PLANNING & ZONING COMMISSION

Regular Meeting Agenda

CITY OF PARKVILLE, MISSOURI

Tuesday, September 14, 2021 5:30 PM

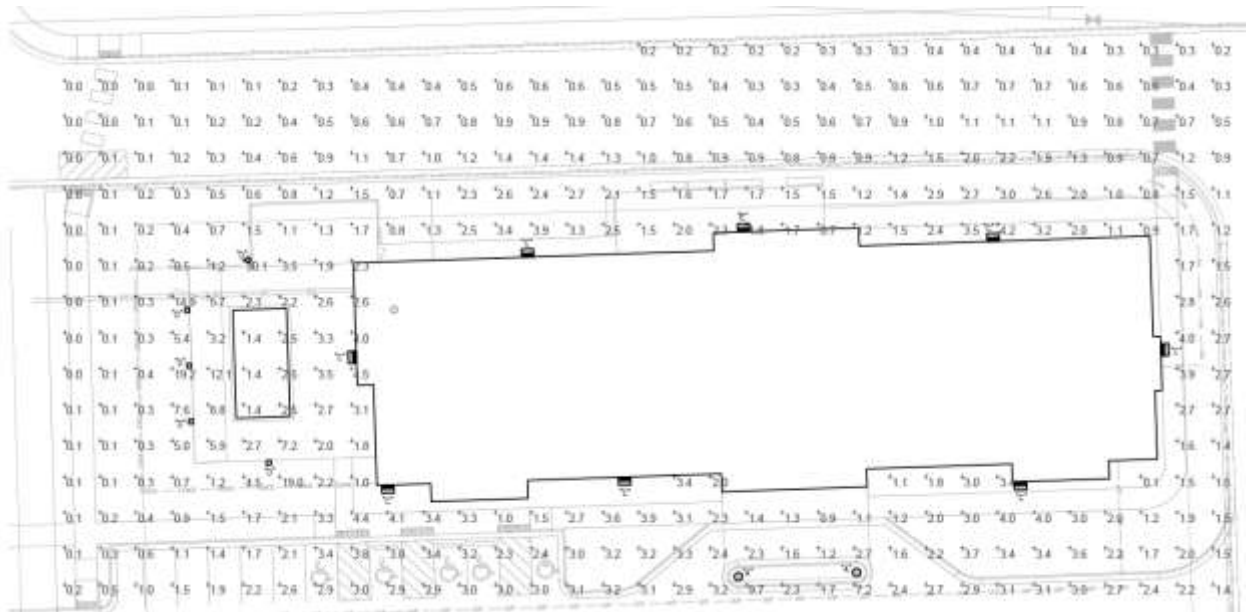
5. **Photometric Plan Sheet** – Please include a lighting plan sheet, in conformance with Section 407.040, showing the location, dimensions/specifications (e.g., mounting height), shielding standards/type and photometric general footprint and impact of lighting throughout the development and on any adjacent properties. See images below as examples.

Site Plan (Sheet C1)

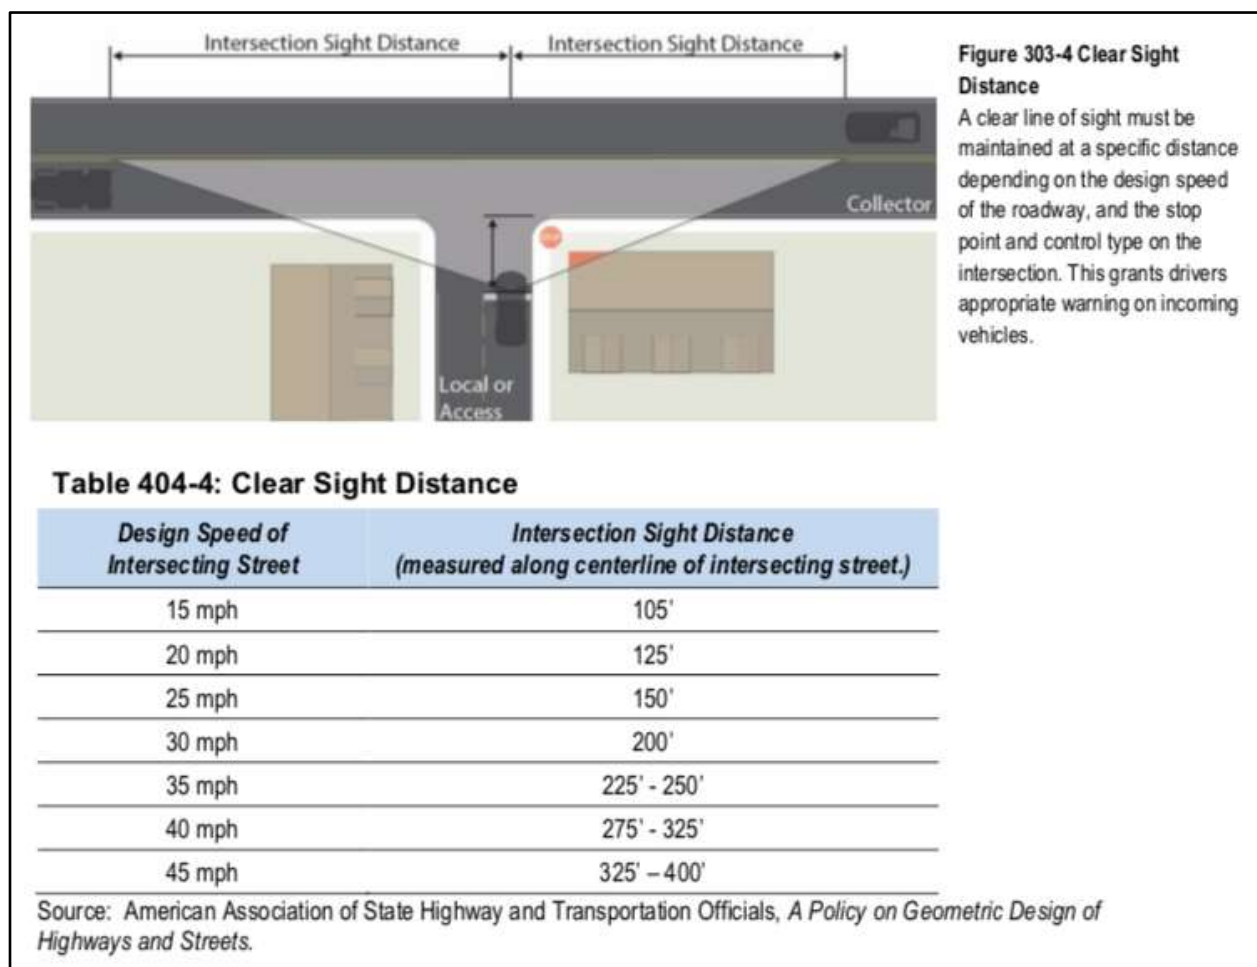
7. **Total Area** – Please label the total area (in acres and sq. ft.) of Phase I and Phase II.
8. **Adjacent Properties** – Please include the labels for the adjacent property owner names & property addresses (if applicable).
9. **Finished Floor Elevations** – Please include the finished floor elevations (FFE) for all buildings on the site plan.
10. **Clear Sight Distance** – Please include sight distance figures at the intersection(s) of the private access roads with Lakeview Dr. These lines of sight shall be an unobstructed view from the stopping point on the approaching street to all points three feet above the roadway along the centerline of the intersecting street. The distance of the unobstructed view shall be based upon the design speed of the intersection street, specified in Table 404-4 of the Title IV – Development Code:

Site Plan – Phase 1 (Sheet C2)

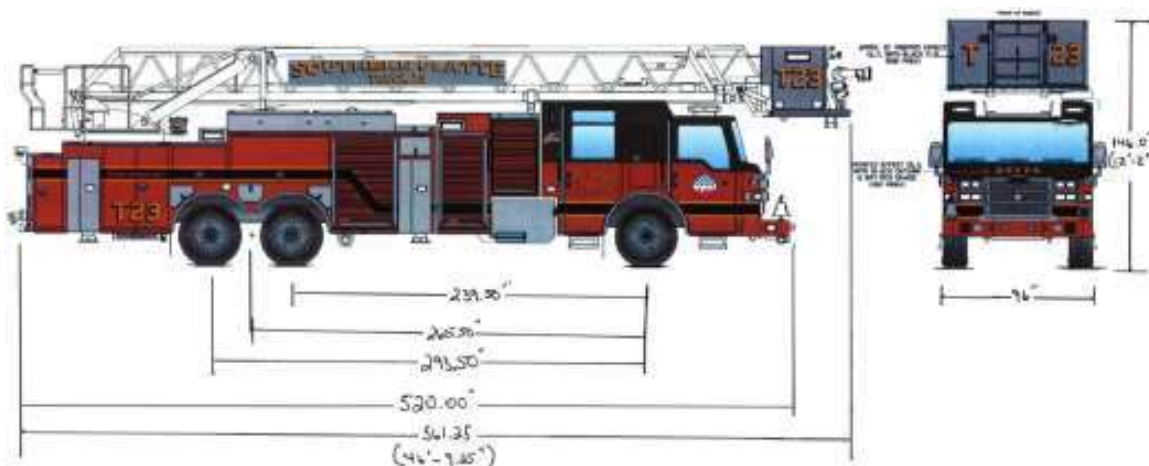
11. **Finished Floor Elevations** – Please include the finished floor elevations (FFE) for all buildings on the site plan.
12. **Clear Sight Distance** – See comment #10 above.
13. **Sidewalk Dimensions** – Please include the sidewalk width dimensions (ft.).

14. **Bicycle Parking** – Per Section 408.030, Subsection D, all multifamily uses within 1,000 ft. of a designated bicycle route or trail (including the Route 9 corridor 10-ft. multi-use trail) shall provide bicycle parking spaces according to Table 408-7: Bicycle Parking; this includes 1 bicycle parking space per dwelling unit. This can be in the form of dedicated bicycle rack or storage spaces outside the building, closet spaces within each dwelling unit, or within the individual carport or garage units. That said, please indicate the number of bicycle parking space types and bicycle spaces provided in the “Parking Summary” table.

15. , or closet spaces within each dwelling unit.
16. **Retaining Wall** – Please note that any retaining walls greater than 48 in. in height will require an Application for Building Permit be submitted to the Community Development Department, as well as a structural engineer’s report for said retaining wall(s).

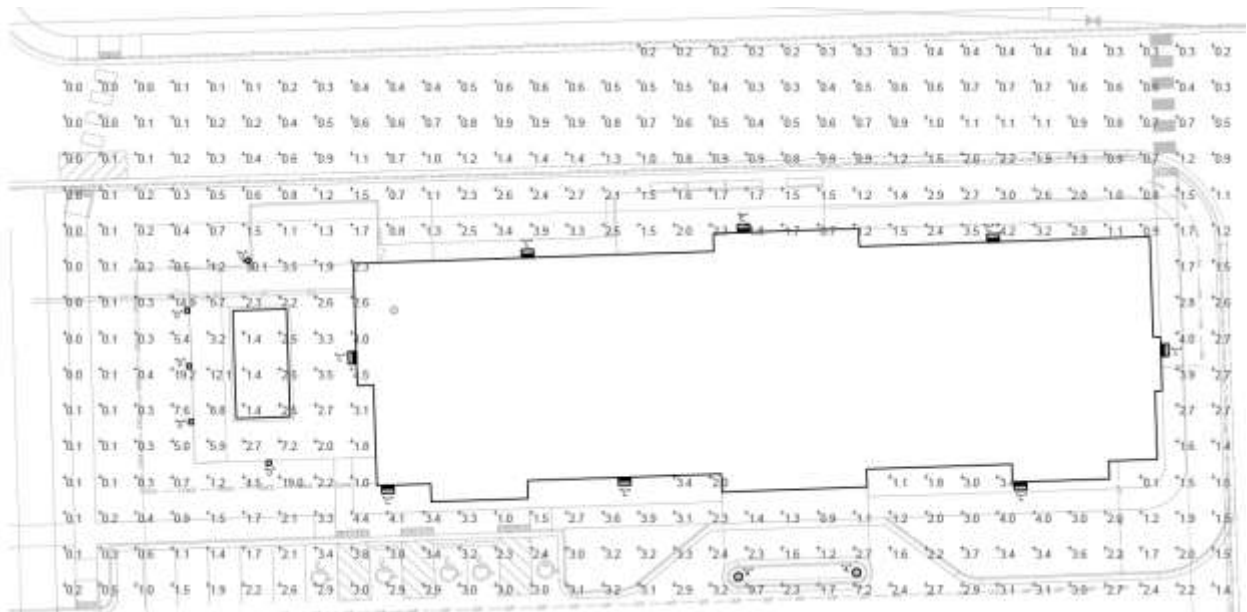
3. **Fire Hydrant Locations** – On the Utility Plan Sheet, please identify the location of fire hydrants to be provided. Please coordinate with Dean Cull (Fire Marshall, Southern Platte Fire Protection District) regarding the proposed location for the fire hydrant, and

whether or not a single fire hydrant is sufficient to provide emergency water service to the entire site per the City's adopted 2018 International Fire Code. Please indicate their locations, as well as utility water line connections to them.

Response: (PEI) Fire hydrants shown and FDC is at water service room by entry to lower level garage. Transformer location shown. Electrical room in basement. Meters are planned to be on wall at north end of the phase 1 building.
